**WILLIAMSON COUNTY, TEXAS**  
**CHANGE ORDER NUMBER: 3**

Project:	<u>22IFB139</u>
Roadway:	<u>FM 3349</u>
CSJ Number:	<u>Williamson Co</u>

**FM3349 at US 79  
Williamson County Project No. 22IFB139**

**Change Order No. 3**

FM 3349  
 UTILITY SLEEVE  
 EXHIBIT

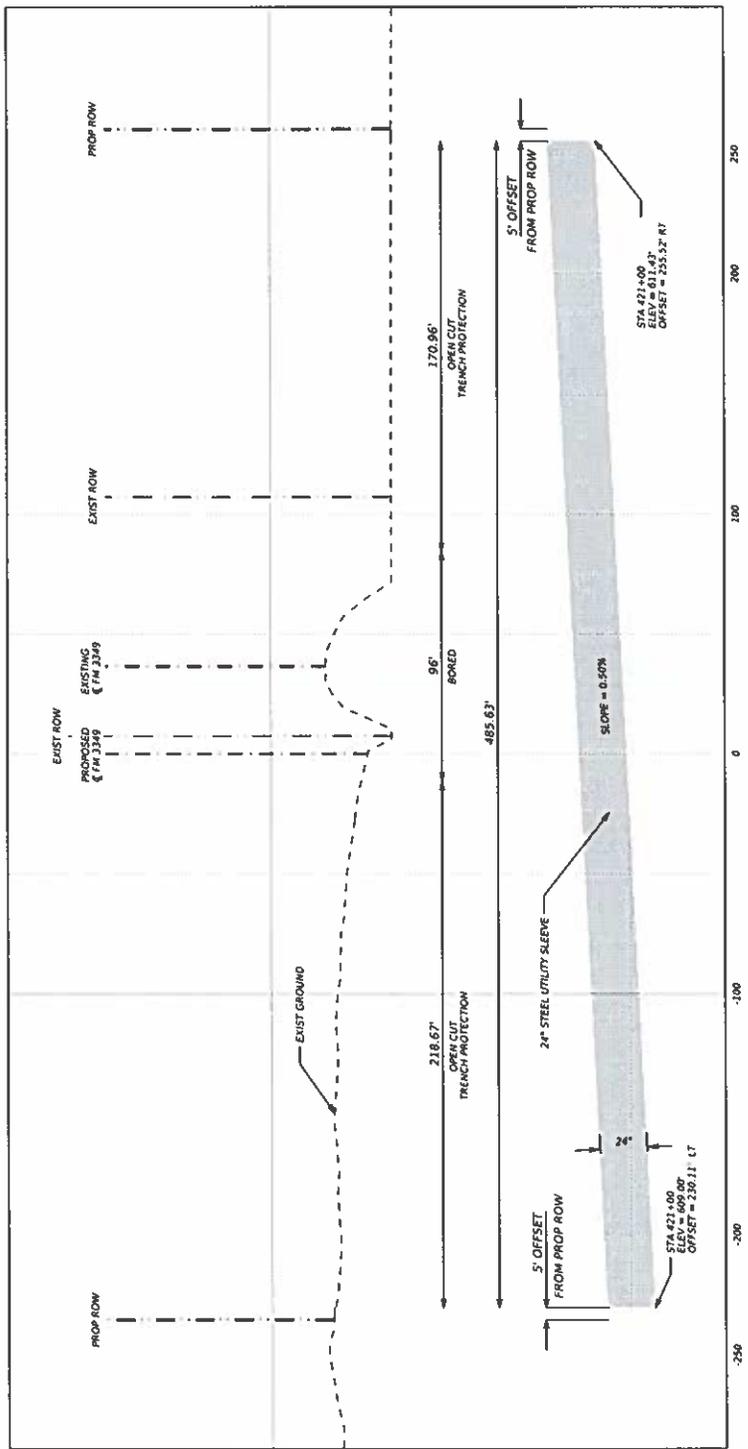
**3. County Convenience. 3F Additional work desired by the County:** This Change Order compensates the contractor for installing one steel utility sleeve casing 24 inches in diameter on FM 3349 at station 421+00.

This Change Order compensates the contractor for installing one steel utility sleeve casing 24 inches in diameter on FM 3349 at station 421+00. The required utility sleeve is listed in section 2.05 of the Real Estate Contract executed on July 27, 2021, that acquired a section of Right-of-Way for the project.

@ FM 3349 STA 421+00  
 486 LF 24" STEEL UTILITY SLEEVE  
 PIPE THICKNESS = 0.375"  
 SLOPE = 0.50%

ITEM	DESCRIPTION	QTY	UNIT
RJ-24.1	Furnish and install 24" Steel Encasement pipe (Bored), 0.0375" thickness	96	LF
RJ-24.2	Furnish and install 24" Steel Encasement pipe (Open Cut), 0.0375" thickness	390	LF
